## HISTORIC AND DESIGN REVIEW COMMISSION

**HDRC CASE NO:** 2019-002  
**ADDRESS:** 825 DAWSON ST  
**LEGAL DESCRIPTION:** NCB 563 BLK 7 LOT 18  
**ZONING:** R-5, H  
**CITY COUNCIL DIST.:** 2  
**DISTRICT:** Dignowity Hill Historic District  
**APPLICANT:** Jeffrey Post  
**OWNER:** Jeffrey Post  
**TYPE OF WORK:** Rehabilitation, exterior and fenestration modifications and the construction of a rear addition  
**APPLICATION RECEIVED:** January 02, 2019  
**60-DAY REVIEW:** March 03, 2019  
**REQUEST:**

The applicant is requesting a Certificate of Appropriateness for approval to:

SHEET:  
**EL-1**

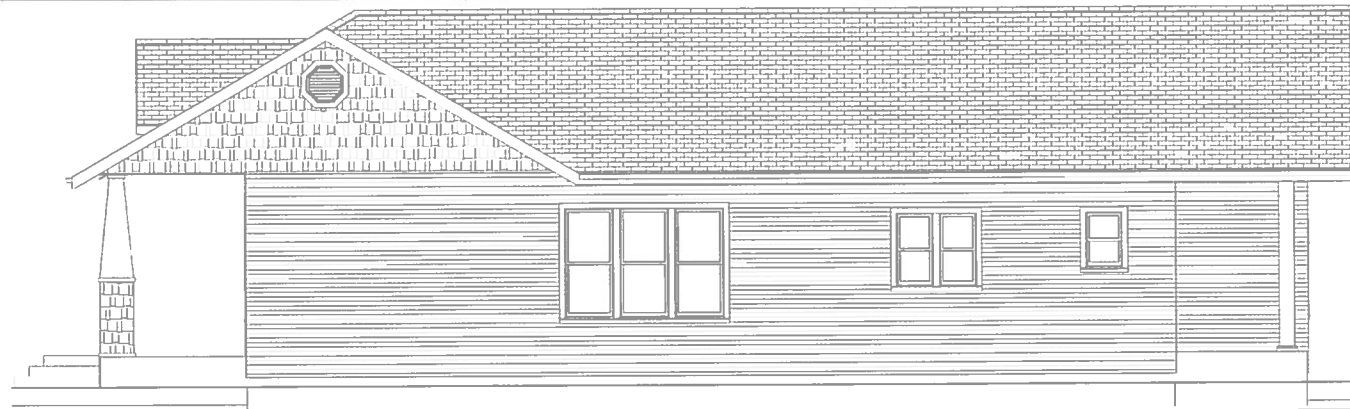
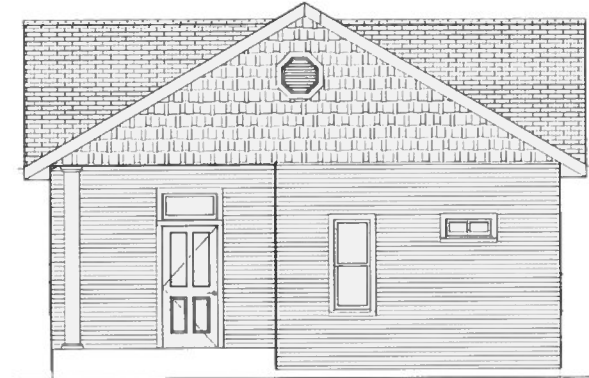
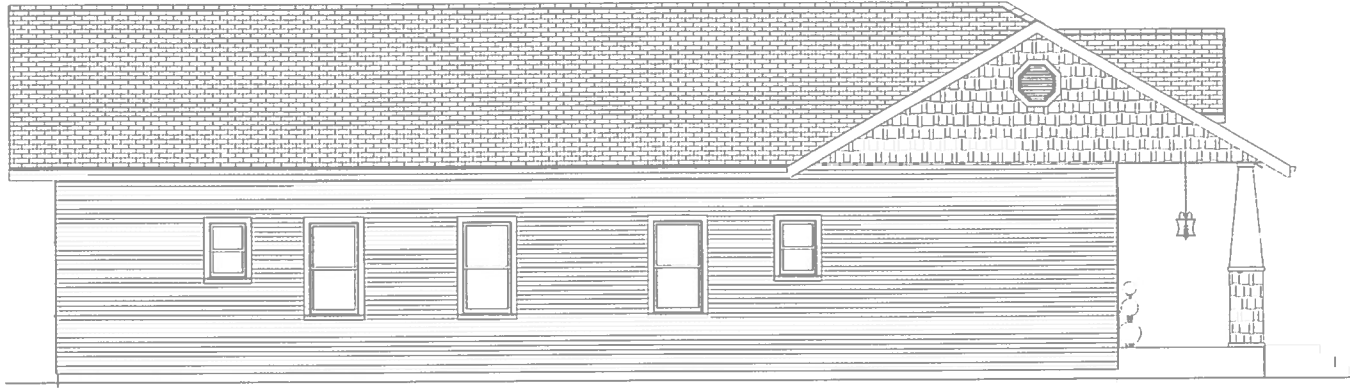
- f. EXTERIOR MODIFICATIONS (Front Façade) – The applicant has proposed to perform exterior modifications to the front (south) façade of the historic structure including the installation of a window on the front façade and the repositioning of the front door to center it on the front façade. The Guidelines for Exterior Maintenance and Alterations 6.A.i. notes that existing window and door openings should be preserved. Per the 1951 Sanborn Map, the structure was a duplex. Staff finds that the left most window façade opening should remain as is, as well as the existing, front door. Staff finds that the applicant may install an additional door to the right of the existing door to address the proposed interior layout. Staff finds that the right most window opening may be modified; however, the opening should remain.

- g. EXTERIOR MODIFICATIONS (East Façade) – The applicant has proposed to perform exterior modifications to the east façade of the historic structure including the removal of three existing window openings and the addition of six new window openings. Modifications to this façade would also result in the removal of the existing, side bay. The Guidelines for Exterior Maintenance and Alterations 6.A.i. notes that existing window and door openings should be preserved. Per the 1951 Sanborn Map, the existing, side bay existed at this time. Staff finds that the side window to the front of the side bay, as well as the side bay and side bay window openings should be preserved. Additionally, the window to the rear of the side bay should be preserved.

- h. EXTERIOR MODIFICATIONS (West Façade) – The applicant has proposed to perform exterior modifications to the west façade of the historic structure including the removal of three existing window openings and the installation of five new window openings. The Guidelines for Exterior Maintenance and Alterations 6.A.i. notes that existing window and door openings should be preserved. Staff finds that each of the original window openings should be preserved.

1. Staff does not recommend approval of item #1, exterior modifications to the historic façade based on finding f. Staff recommends that the left most window façade opening remain as is, as well as the existing, front door. Additionally, staff recommends that the applicant install an additional door to the right of the existing door to address the proposed interior layout. The right most window opening may be modified; however, the opening should remain.

2. Staff does not recommend approval of item #2, exterior modifications to the historic façade based on finding g. Staff recommends that the existing window openings and side bay be preserved as they exist.

3. Staff does not recommend approval of item #3, exterior modifications to the historic façade based on finding h. Staff recommends that the existing window openings be preserved.
